UNITED STATES PATENT AND TRADEMARK OFFICE

APPLICATION NO.	FILING DATE	FIRST NAMED INVENTOR	ATTORNEY DOCKET NO.	CONFIRMATION NO.
10/562,581	12/28/2005	Susumu Okazaki	36856.1389	7909

Office Action Summary	Application No. 10/562,581	Applicant(s) OKAZAKI ET AL.	
	Examiner Derek J. Rosenau	Art Unit 2834

DETAILED ACTION

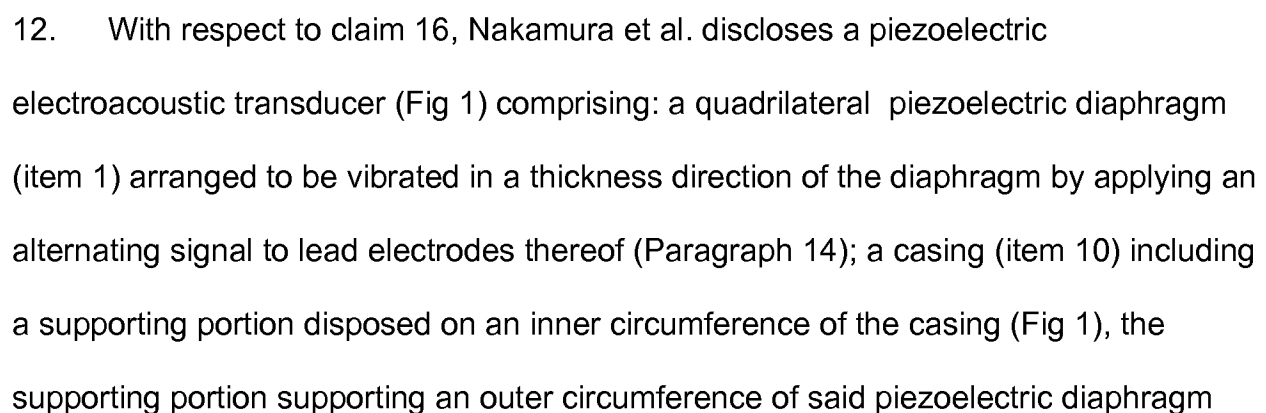
9. With respect to claim 13, the combination of Nakamura et al. and Mizusawa discloses a piezoelectric electroacoustic transducer according to claim 7. Nakamura et al. discloses that the casing includes a receiving step (see figure below, figure 8 from Nakamura et al.) having a height lower than the supporting portion and a predetermined space between the receiving step and the bottom surface of the diaphragm (Fig 8).
